| Subject: Coolant Hoses Replacement | | | |
| Field Change Program: Field Campaign | FCP Number: FCP 486 | Revision: | Date: 10/27/2020 |
| Coach Section: 06 - Cooling | P/N: 06-08-1006, 16-11-1970 | | Type: Safety Recall |

| Ref. NHTSA Recall No.: 20V-526 | Ref. Transport Canada Recall No.: 2020-501 |

Locate the coolant hose 16-11-1970

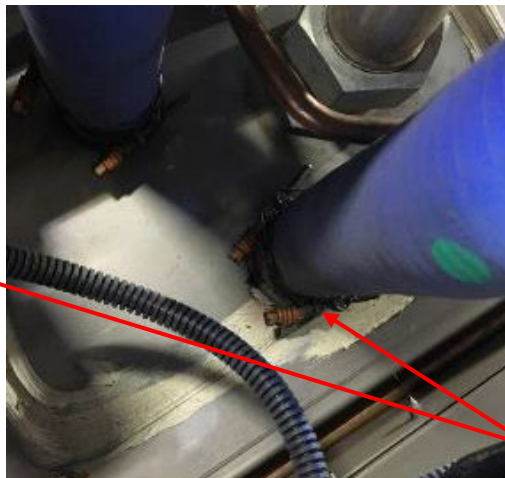
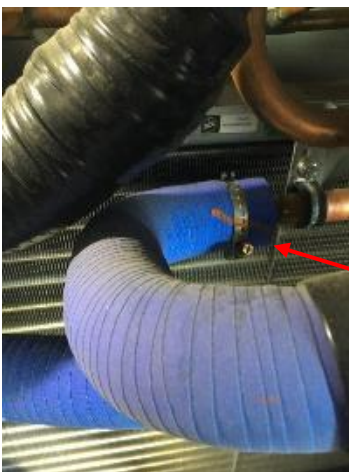
Locate the evaporator hot water coolant hose, MCI P/N: 16-11-1970.

Remove and save the nuts and bolts securing clamp on the coolant hose. Save the clamp.

Remove and save
bolt, nut and clamp

Remove and discard
the clamps and hose

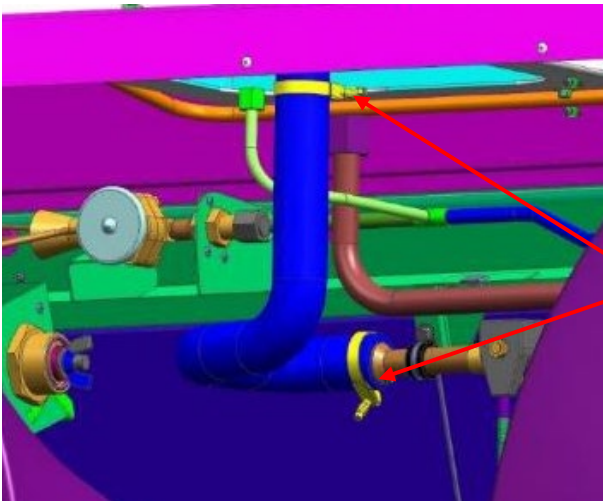
Remove and discard the clamps securing the hose. Discard the hose.

Install new hose, 16-
11-2768, using
clamps, 19-4-205

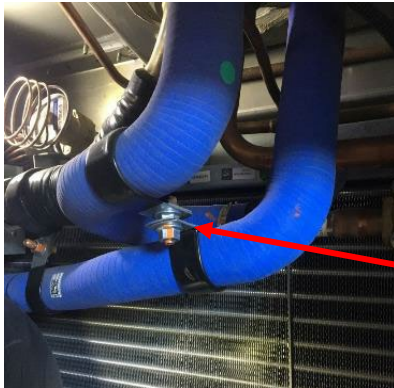
Install the new coolant hose, MCI P/N: 16-11-2768, using two new clamps, MCI P/N: 19-4-205. Torque the clamps to 18 In-Lb.

Reinstall the clamp using the existing bolt and nuts.

Reinstall the clamp using existing nuts and bolt

Remove and discard
the clamps and hose

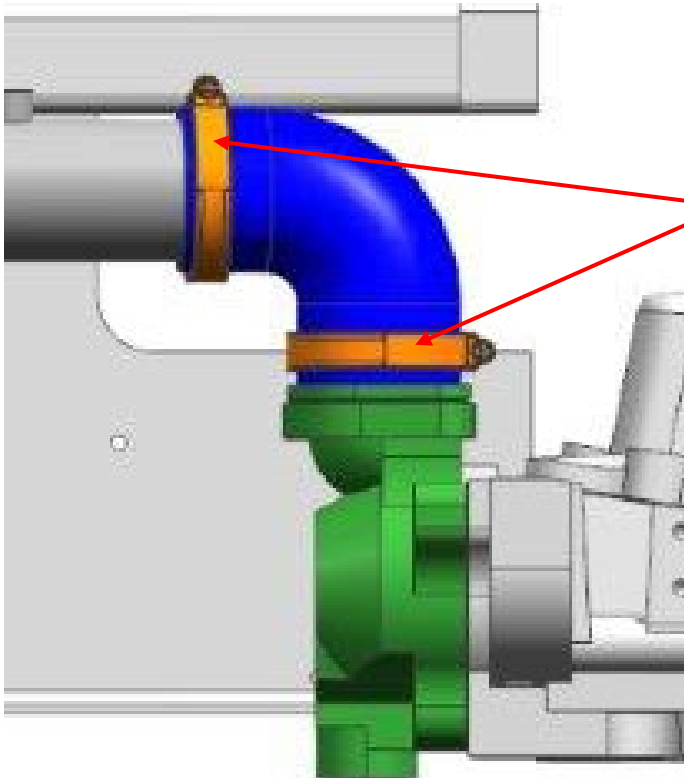
Remove and discard the two clamps securing the coolant elbow hose. Discard the hose.

Install the new elbow hose, MCI P/N: 06-08-2261, using two new clamps, MCI P/N: 19-04-0520. Torque clamps to 105 In-Lb.

Install new hose, 06-08-
2261, using clamps, 19-
04-0520

Install the new elbow
hose, 06-08-2261

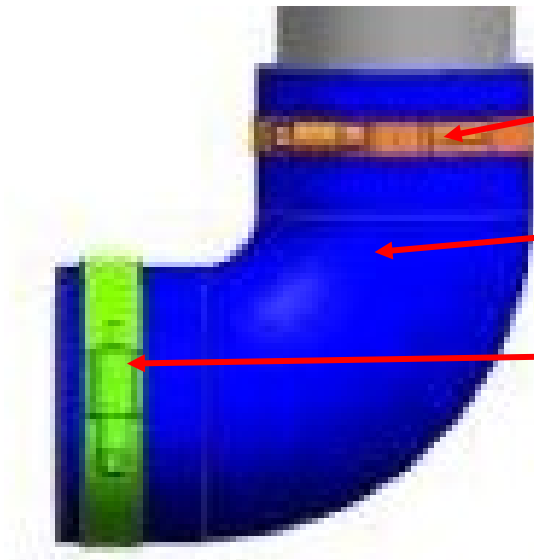
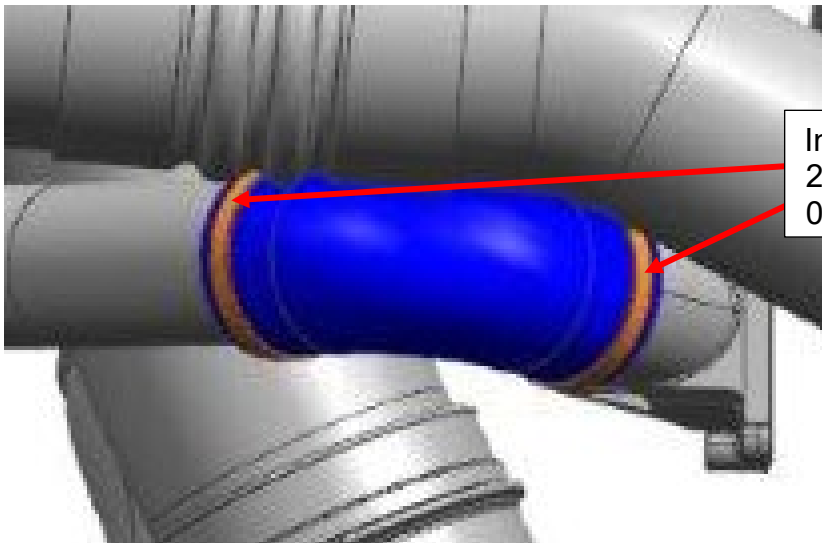
Remove and discard the clamps securing the coolant elbow hose #1. Discard the hose.

Remove and discard
elbow hose and clamps

Install the new elbow hose, MCI P/N: 06-08-2261, using the wider clamp, MCI P/N: 19-4-150, towards the radiator and the thinner clamp, MCI P/N: 19-04-0520, towards the engine. Torque the wider clamp to 115 In-Lb and thinner clamp to 105 In-Lb.

Thinner clamp, 19-04-0520

Wider clamp, 19-4-150

Install new hose 06-08-
2261, using clamps, 19-
04-0520

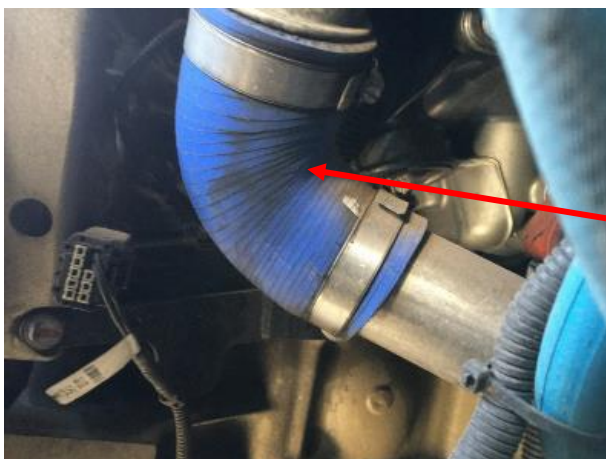
Remove and discard the clamps securing the coolant elbow hose #2. Discard the hose.

Remove and discard
clamps and hose

Install the new elbow hose, MCI P/N: 06-08-2261, using new clamps, MCI P/N: 19-04-0520. Torque the clamps to 105 In-Lb.

Install new hose 06-08-2261, using clamps, 19-04-0520

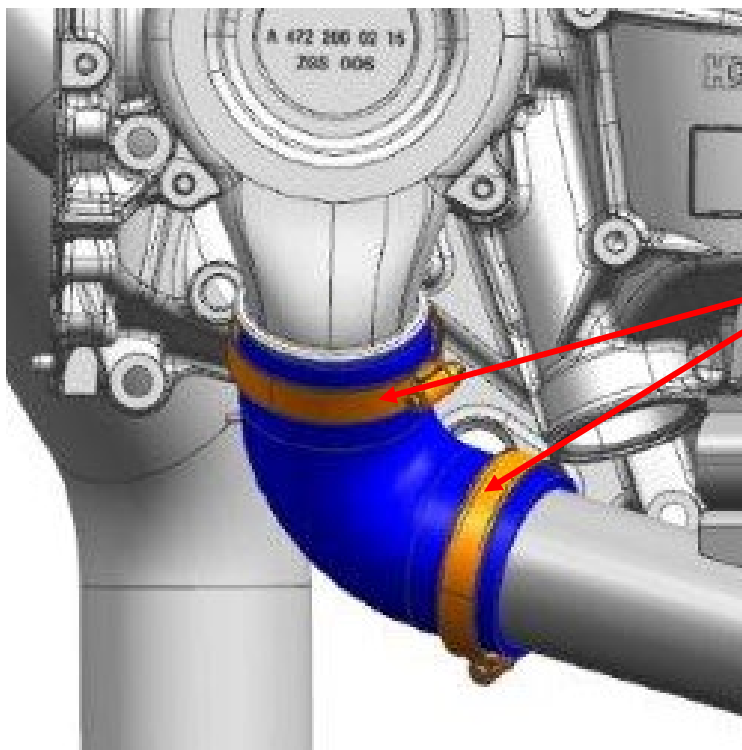
Remove and discard the clamps securing the coolant elbow hose #3. Discard the hose.

Remove and discard
clamps and hose

Install the new elbow hose, MCI P/N: 06-08-2261, using new clamps, MCI P/N: 19-04-0520. Torque the clamps to 105 In-Lb.

Remove and discard
hose elbow and clamps

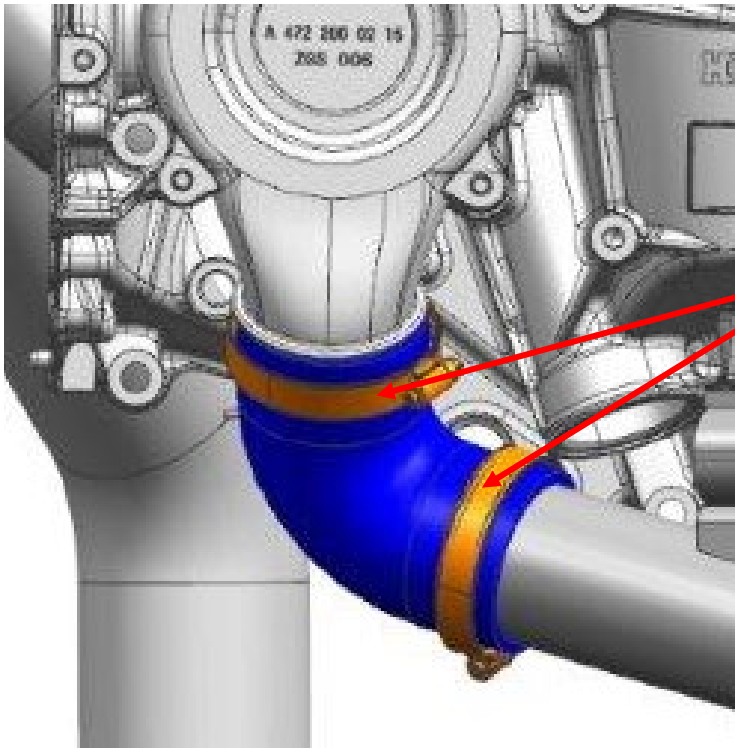
Remove and discard the coolant hose elbow and the two hose clamps.

Install the new elbow hose, MCI P/N: 06-08-2261, using new clamps, MCI P/N: 19-04-0520. Torque the clamps to 105 In-Lb.

Install new hose 06-08-2261, using clamps, 19-04-0520

Remove and discard
elbow hose and clamps

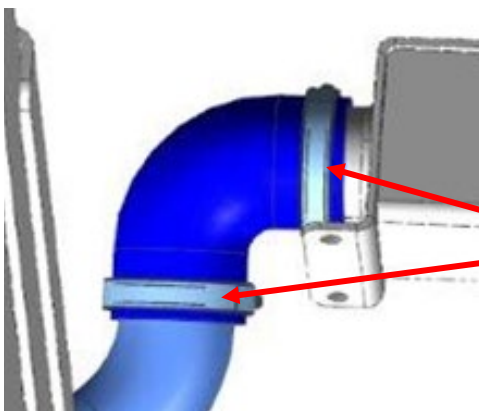
From under the coach, remove the clamp securing the coolant hose. Discard the hose

Install the new elbow hose, MCI P/N: 06-08-2261, using new clamps, MCI P/N: 19-04-0520. Torque the clamps to 105 In-Lb.

Install new hose 06-08-2261, using clamps, 19-04-0520
